PIC16C64A Rev. A Silicon Errata Sheet

The PIC16C64A (Rev. A) parts you have received conform functionally to the Device Data Sheet (DS30234D), except for the anomalies described below.

In the Device Data Sheet (DS30234D), the following clarifications and corrections should be noted.

FIGURE 1: SCK PULSE VARIATION USING TIMER2/2

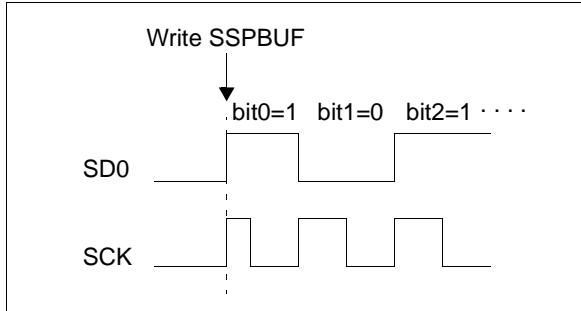
4. Module: SSP (SPI Mode)

When the SPI is using Timer2/2 as the clock source, a shorter than expected SCK pulse may occur on the first bit of the transmitted/received data (Figure 1).

To avoid producing the short pulse, turn off Timer2 and clear the TMR2 register, load the SSPBUF with the data to transmit, and then turn Timer2 back on. Refer to Example 1 for sample code.

FIGURE 1: WRITES TO TIMER1 (EXTERNAL CLOCK/OSCILLATOR MODE)

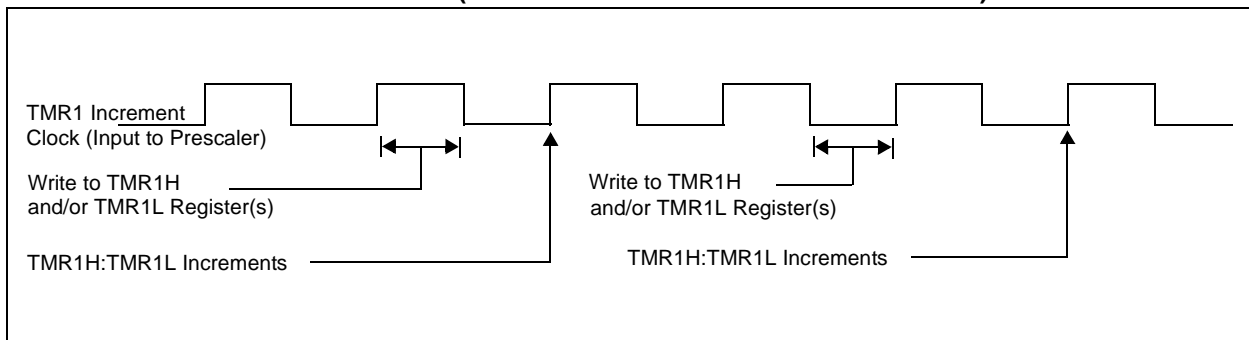
3. Module: Timer1

The operation of Timer1 needs some clarification when the timer registers are written and the TMR1ON bit is set.

The internal clock signal, that is the input to the TMR1 prescaler, affects the incrementing of Timer1 (TMR1H:TMR1L registers and the Timer1 prescaler). When the Timer1 registers are NOT written, the Timer1 will increment on the rising edge of the TMR1 increment clock.

When the TMR1H and/or TMR1L registers are written while this clock is high, TMR1 will increment on the next rising edge of this clock.

When the TMR1H and/or TMR1L registers are written while this clock is low, TMR1 will not increment on the next rising edge of this clock, but must first have a falling clock and the rising clock for TMR1 to increment.

Figure 1 shows the two cases of writes to the TMR1H and/or TMR1L registers. Due to the V_{IH} and V_{IL} thresholds on the oscillator/clock pins, external Timer1 oscillator components, and external clock frequency, the Timer1 increment clock may not be of a 50% duty cycle.

The TMR1 increment clock is out of phase of the T1OSO/T1CKI pin by a small propagation delay.
